**PLANNING COMMISSION
Meeting Agenda (Revised)
Monday – February 24, 2014
7:00 PM**

SUBDIVISION STAFF REPORT

FILE #: SUB 13-01

The applicant is requesting approval of a 10.3 acre subdivision for 33 single family home lots. This is the second phase of the four phase development of the Northwoods Estates subdivision. The latest extension of the approved SUB 05-12, Master Plan, and Development Agreement is included in the Planning Commission packet.

Figure 16.43.1: Light Trespass

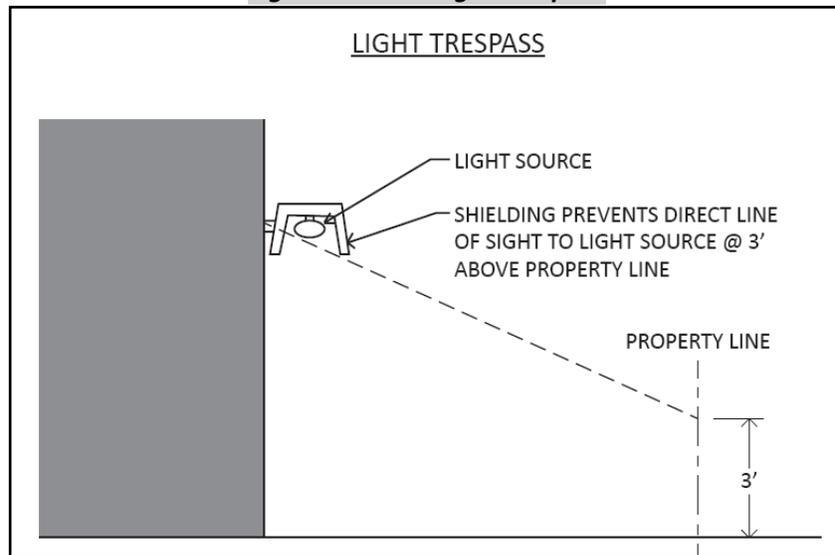
Findings: The code states above that “Streetlights shall be fully shielded”. The definitions below and the depiction above attempt to clarify the meaning of “fully shielded”; in addition an internet search provides many pictorial examples of shielded lighting:

For the lighting along NW 10th Avenue, the applicant states that they plan to use an LED cobra on each of the existing wood poles and will look identical to the existing lighting along NW 10th Avenue except that it will be LED. (see Google Earth picture below). The applicant also included a GE lighting brochure that depicts the designs for the “GE Evolve” style lighting proposed along 10th Avenue.

The Planning Commission should determine if this proposed lighting is satisfactory or if alternative lighting with more shielding should be required.

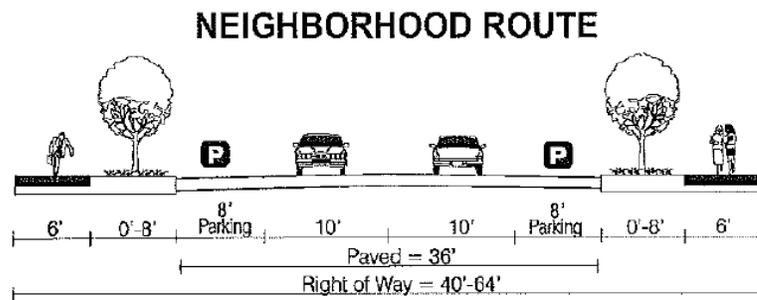
Findings: The proposed streets to the greatest extent possible extend to surrounding street patterns and layouts:

- NW 10th Avenue is proposed to be extended with this development.
- NW 11th is restricted by surrounding properties from allowing extension.
- “B” Street, to be named “NW 11th Place”, is restricted by surrounding properties from allowing extension.
- N Douglas will connect NW 10th with NW 11th.
- Elm Street will be extended to NW 10th.
- NW 12th will be extended from the existing streets to the west and east; the existing east/west layout of NW 12th is not aligned and therefore NW 12th takes a north/south jog at Elm.

1 N ELM STREET SECTION
WEST SIDE AND EAST SIDE (MIRRORED) OF PARK

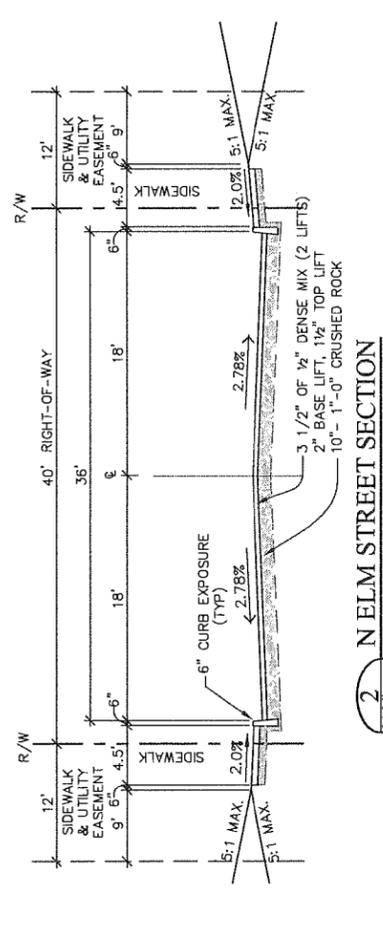
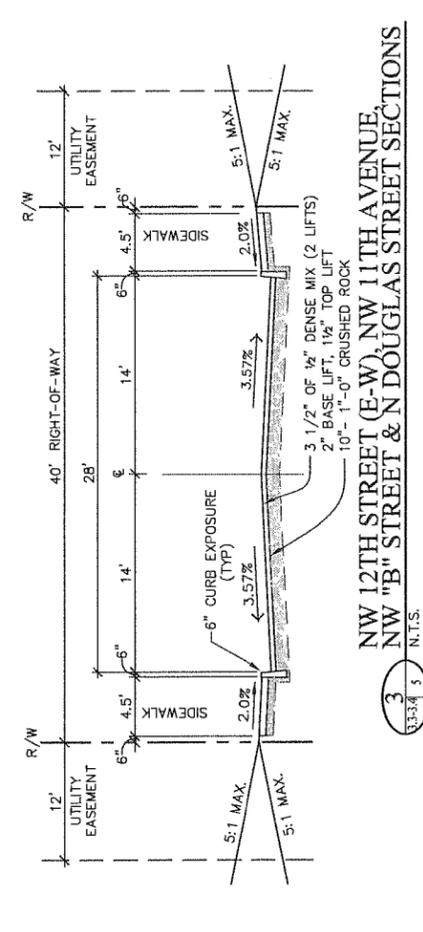
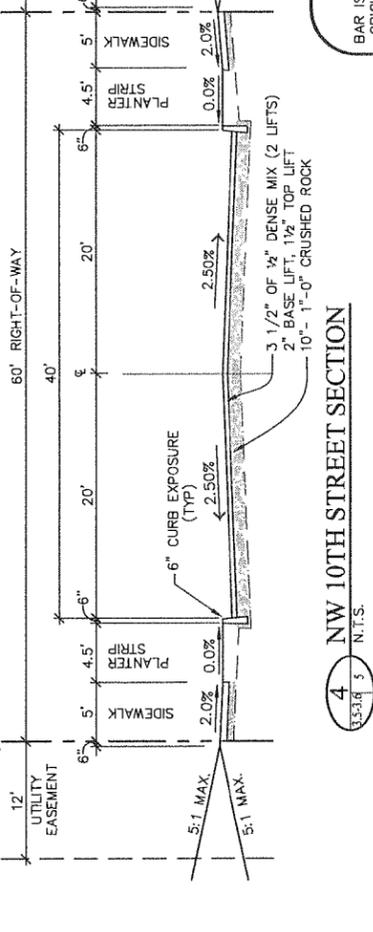
- Discuss/comment on the proposed street cross sections and conformance with TSP standards. See 16.64.010(A)(3) page 23-25.

- Discuss/comment on proposed 4.5' sidewalks with a 6" curbs. Determine if 6 foot sidewalks should be required; specify if the 6" curb is to be included in sidewalk width measurement. See 16.64.010(A)(3) page 24.

- Discuss/comment on applicant's proposed curb-tight sidewalks along NW 12th Avenue. See 16.64.010(A)(3) page 24-25.
- Discuss/comment on Douglas Street alignment with the existing Douglas spur off NW 9th. See 16.64.010 (D) page 26.

Findings: Elm Street adjacent to the park strip is proposed to be 20' wide, short of the above 28' standard. However, adding both one-way portions of Elm would make a 40' road. The applicant's narrative stated plans for no parking along the one-way portions of Elm and the Fire Department submitted comments that they would like 20' clear isles. Therefore **Condition #22** is proposed that prohibits parking along the one-way portions of Elm in the form of no parking signs and/or painted curbs.
